CNS-15-075

Subject: Duke Energy Carolinas, LLC (Duke Energy)  
Catawba Nuclear Station, Units 1 and 2  
Docket Numbers 50-413 and 50-414  
License Amendment Request (LAR) for Changes to Technical Specification (TS)  
3.3.2, "Engineered Safety Feature Actuation System (ESFAS) Instrumentation"  
and TS 3.3.5, "Loss of Power (LOP) Diesel Generator (DG) Start Instrumentation"  
Resolution of Operable But Degraded Condition Due to Non-Conservative TS  
Response to NRC Request for Additional Information

**RESPONSE TO NRC REQUESTS FOR ADDITIONAL INFORMATION (RAIs)**

Subject: License Amendment Request (LAR) for Changes to Technical Specification (TS)  
3.3.2, "Engineered Safety Feature Actuation System (ESFAS) Instrumentation"  
and TS 3.3.5, "Loss of Power (LOP) Diesel Generator (DG) Start  
Instrumentation"  
Resolution of Operable But Degraded Condition Due to Non-Conservative TS

UNIT 1

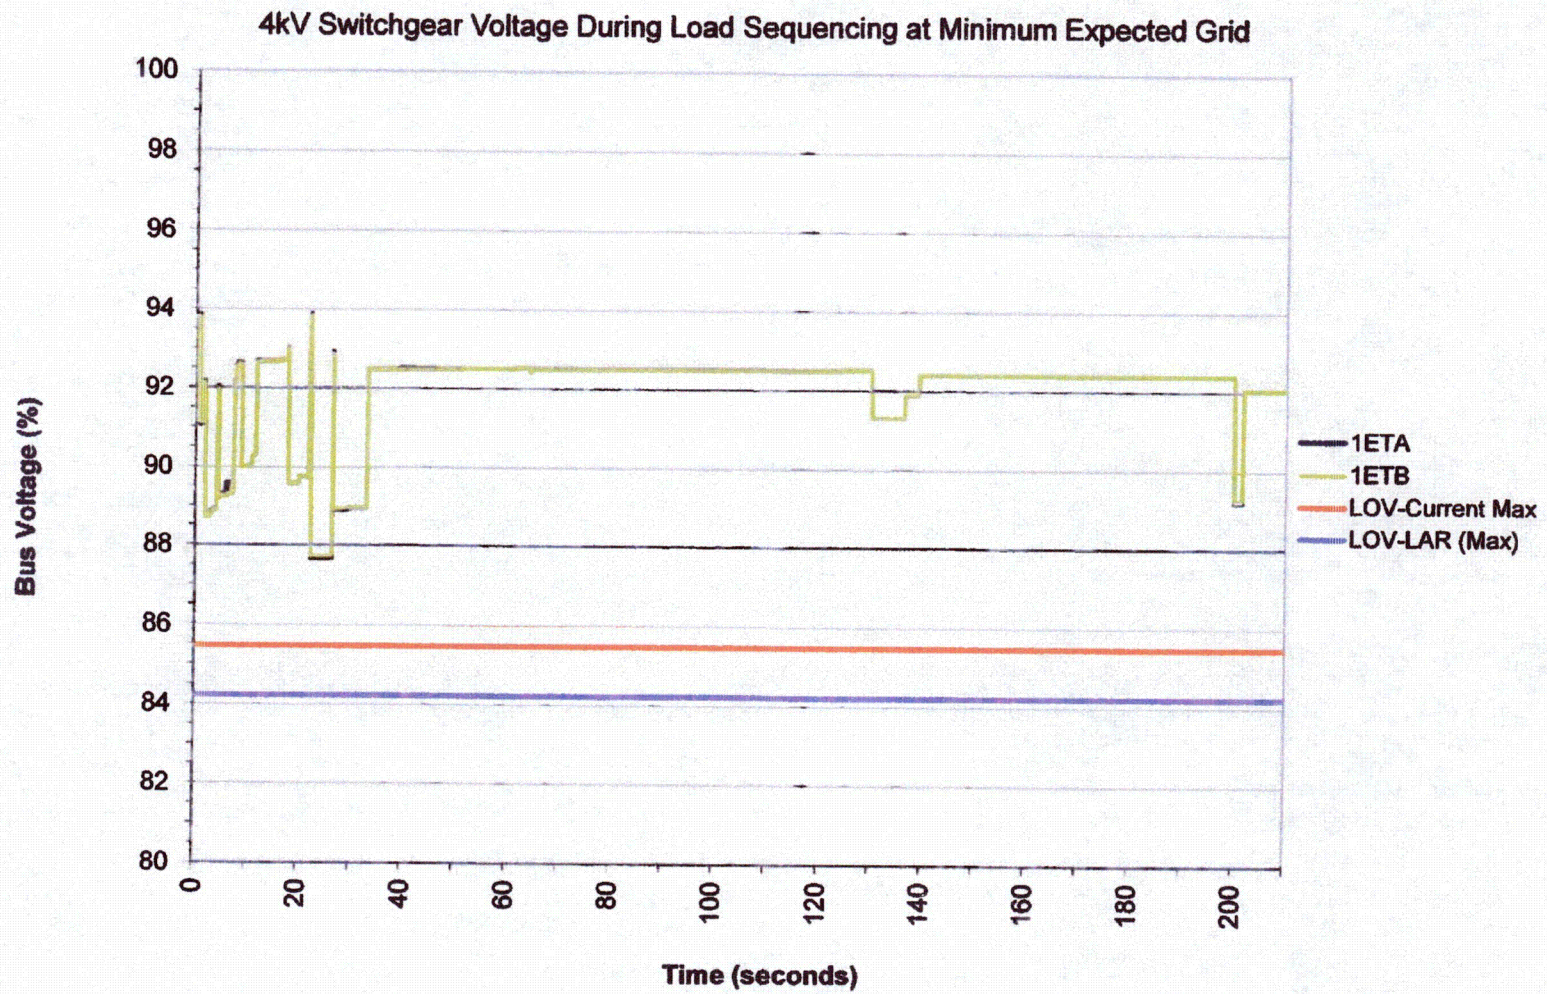
6. Please provide a curve showing the minimum voltages at the 4160 V safety-related buses during the starting of LOCA loads after the safety injection signal based on the minimum switchyard voltage (based on agreement with the transmission system operator). Super-impose on this curve, the analytical and reset voltage values of the undervoltage relay settings to demonstrate that adequate margin exists so that the motors would not trip out by the undervoltage relay during a LOCA load sequencing.

**Unit 1 figure:**

**The maximum loss of voltage trip setpoint is used in the figure.**

**This maximum value assumes that the relay has drifted to the maximum value dictated by the total loop uncertainty. This figure shows that the 4.16 kV switchgear voltage does not dip to 85.48% (current loss of voltage trip maximum setpoint). Additionally, the requested value for the loss of voltage relay setpoint (adjusted to the maximum drift value) of 84.23% is also shown on the figure.**
